# Current ENERGY STAR Certified Homes Policy Record

## ENERGY STAR Certified Homes Policy Record

**Exhibit 1: Floor Cavity Adjacent to Outdoors & Over Unconditioned Basement**

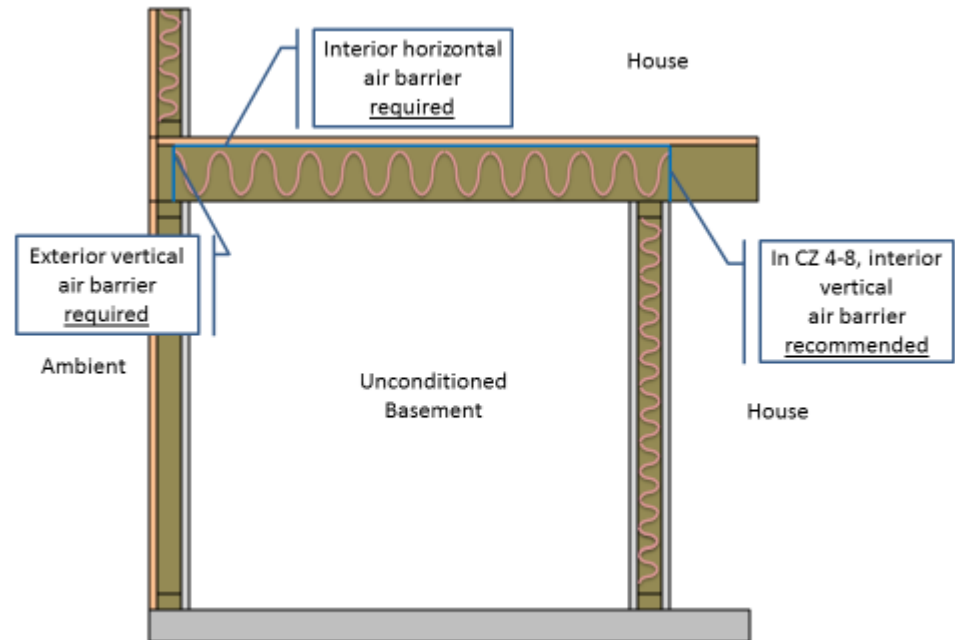
In Exhibit 1, the floor is adjacent to the outdoors and over an unconditioned basement. An air barrier is therefore required at the exterior vertical surface of the floor insulation and at the interior horizontal surface of the insulation. In addition, if the home was in CZ 4-8, an air barrier would also be recommended, but not required, at the interior vertical surface of the insulation.

**Exhibit 2: Floor Cavity Adjacent to Outdoors & Over Unconditioned Garage**

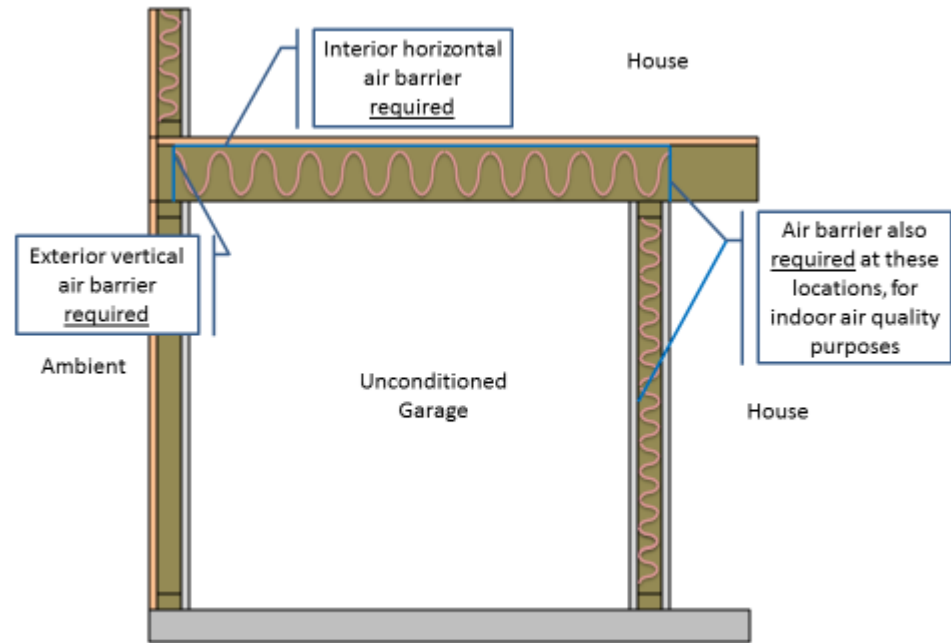
Exhibit 2 illustrates a similar configuration, except that the floor is located over an unconditioned garage. In this case, the same air barriers are required for thermal purposes. However, for

indoor air quality purposes, an air barrier is also required at the wall that separates the attached garage from occupiable space and, also, an air barrier must be installed and sealed at the floor cavity aligned with this wall.

**Exhibit 4: Floor Cavity Adjacent to Unconditioned Porch Roof**

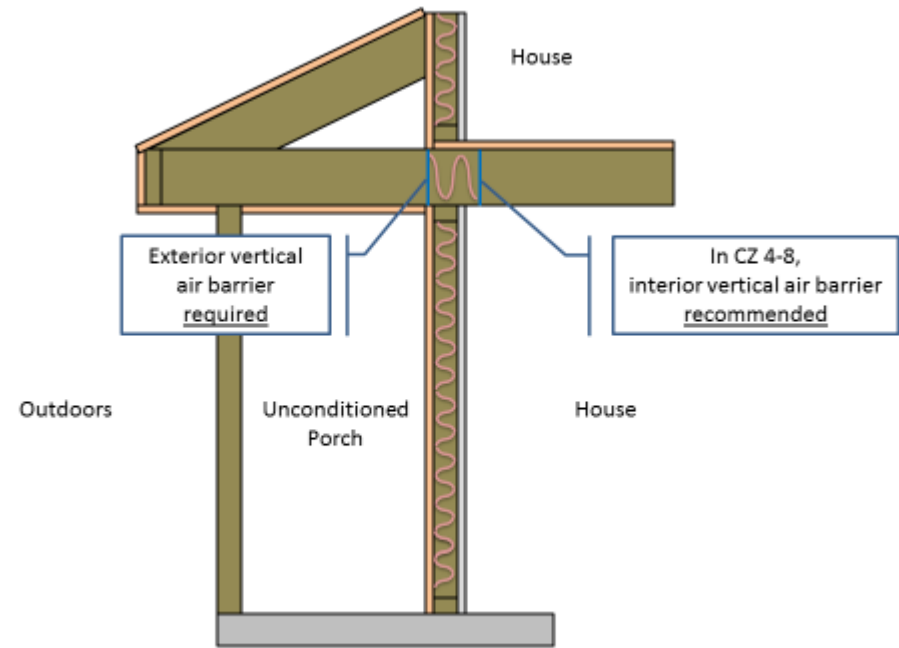
Exhibits 3 & 4 show configurations where the floor cavity is adjoining unconditioned space, the outdoors and a porch roof, respectively. However, in both cases, these floors are not located over unconditioned space. Therefore, the only air barrier required is at the exterior vertical surface of the insulation. If these configurations were located in CZ 4-8, then an interior vertical air barrier would also be recommended, but not required.

**Exhibit 5: Floor Cavity Adjacent to & Over Outdoors**

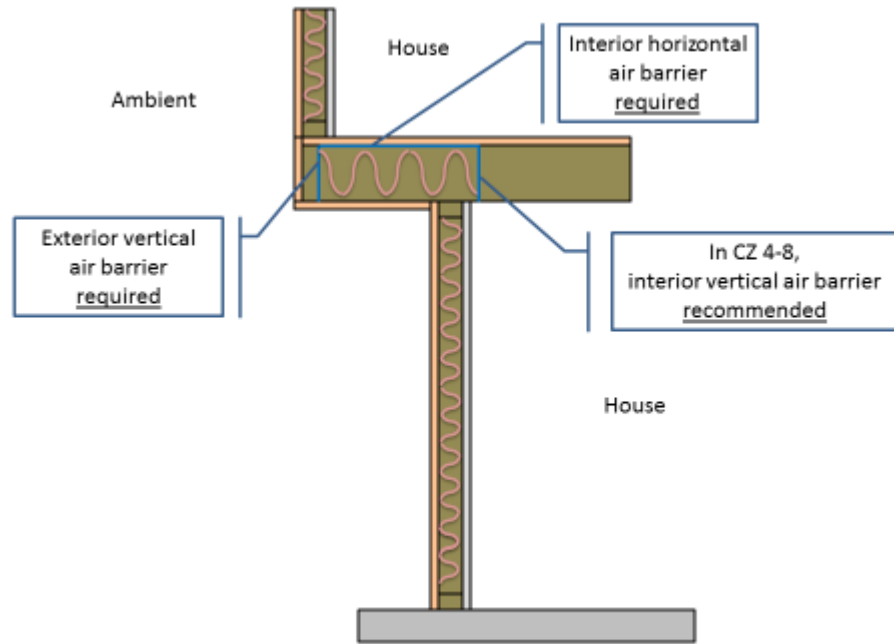
In Exhibit 5, a cantilever configuration is illustrated, in which the floor is both adjacent to and over the outdoors. Therefore, an air barrier is required at the exterior vertical surface of the insulation and at the interior horizontal surface of the insulation. If the configuration was located in CZ 4-8, then an interior vertical air barrier would also be recommended. Finally, as a best practice, an air barrier would also be included at the exterior horizontal surface of the insulation.

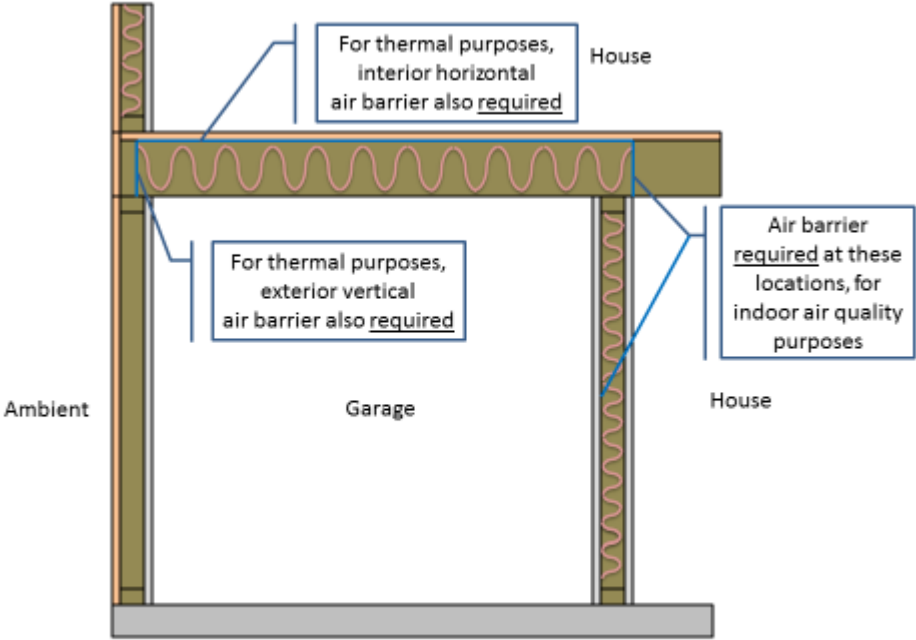
00429	05/01/2014	Thermal Enclosure System Rater Checklist (Version 3, Rev. 07)	Change	<p><b>Item 4.4.5e – Removal of requirement for 24” o.c. spacing or R-20 cavity insulation in CZ 5</b></p> <p><b>Issue:</b> Partners have expressed difficulty complying with the requirements of Item 4.4.5e, which requires in part that homes in Climate Zones 5 through 8 using 2x6 framing place studs 24” on-center or, per Footnote 22, use 2x6 framing with 16” o.c. stud spacing plus R-20 cavity insulation.</p> <p>These partners have suggested that the use of 2x4 framing with 16” on-center spacing and R-13 or R-15 cavity insulation is still standard practice in many parts of Climate Zone 5. While this wall assembly would not satisfy the requirements of the ENERGY STAR Certified Homes program, upgrading a wall system to 2x6 framing is a significant investment in, and improvement of, the thermal enclosure system relative to this practice. Therefore, partners have suggested that the additional requirement for 24” on-center spacing or R-20 cavity insulation acts as a deterrent to upgrading to 2x6 framing.</p> <p>Furthermore, advanced insulation products capable of achieving R-20 cavity insulation still incur a substantial cost increase in markets where such products are not yet commonplace.</p> <p>Primarily for these two reasons, partners have requested that the requirement to use 24” on-center spacing or R-20 cavity insulation for walls with 2x6 framing be removed from Climate</p>

<p>Zone 5. Note that no challenges have been identified to meeting this requirement in Climate Zones 6 through 8, where 2x6 framing is more commonplace.</p> <p><b>Resolution:</b> To address the partner concerns cited above about the requirements in Item 4.4.5e for homes with 2x6 framing in Climate Zone 5, this Item will be revised by removing these requirements only in Climate Zone 5. To reflect this change, the Climate Zones referenced in Item 4.4.5e will be revised as follows:</p> <p>“Minimum stud spacing of 16 in. o.c. for 2x4 framing in all Climate Zones and, in Climate Zones 6 through 8, 24 in. o.c. for 2x6 framing”.</p> <p>In addition, the Climate Zones in Footnote 22 will be revised as follows:</p> <p>“In Climate Zones 6 - 8, a minimum stud spacing of 16 in. o.c. is permitted to be used with 2x6 framing if <math>\geq</math> R-20.0 wall cavity insulation is achieved. However, all 2x6 framing with stud spacing of 16 in. o.c. in Climate Zones 6 - 8 shall have <math>\geq</math> R-20.0 wall cavity insulation installed regardless of any framing plan or alternative equivalent total UA calculation.”</p> <p>Note that despite this change, homes are still required to meet the insulation levels defined in Item 2.1. Therefore, homes using R-19 cavity insulation in Climate Zone 5 may need make improvements in the other insulated assemblies or the fenestration to meet Item 2.1.</p>
